Environmental Impact Assessment Scoping Opinion for the Proposed Cruise Berthing and Cargo Enhancement Project

25 February 2020

Figure 1. The Biodiversity Mitigation Hierarchy from Good Practices for Biodiversity Inclusive Impact Assessment and Management Planning (July 2015).

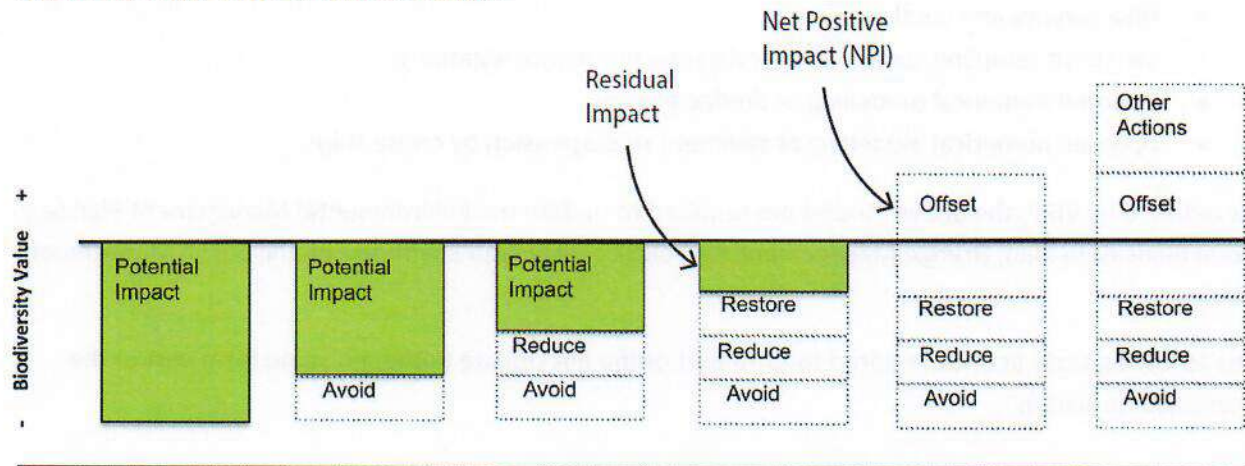
The land-based coral nursery meets some of the requirements (e.g. mitigation hierarchy, additionality) but not all. The land-based coral nursery does not provide landscape-level conservation as it will be a land-based activity. Beyond the propagation of individual corals, the nursery would not be able to mitigate for the loss of ecological processes and functions of the landscape. Given the scale of the CBCEP, the proposed land-based coral nursery does not provide an adequately compensatory scale. The good practice guide also indicates that the offset should be expanded in size to accommodate uncertainties in design and expected effectiveness of the offset. There is a high degree of uncertainty with the land-based nursery. The proposed land-based coral nursery does not provide like-for-like or out-of-kind trading up, as a reef ecosystem will be lost. The loss of coral habitat to the CBCEP is a nearly permanent effect. Although we understand that there is a 25 year commitment to the land-based coral nursery, in line with the 25 year life of the contractual agreement, the land-based coral nursery will not endure as long as project impacts.

As per Figure 1, the land-based coral nursery can be considered an 'other action'.
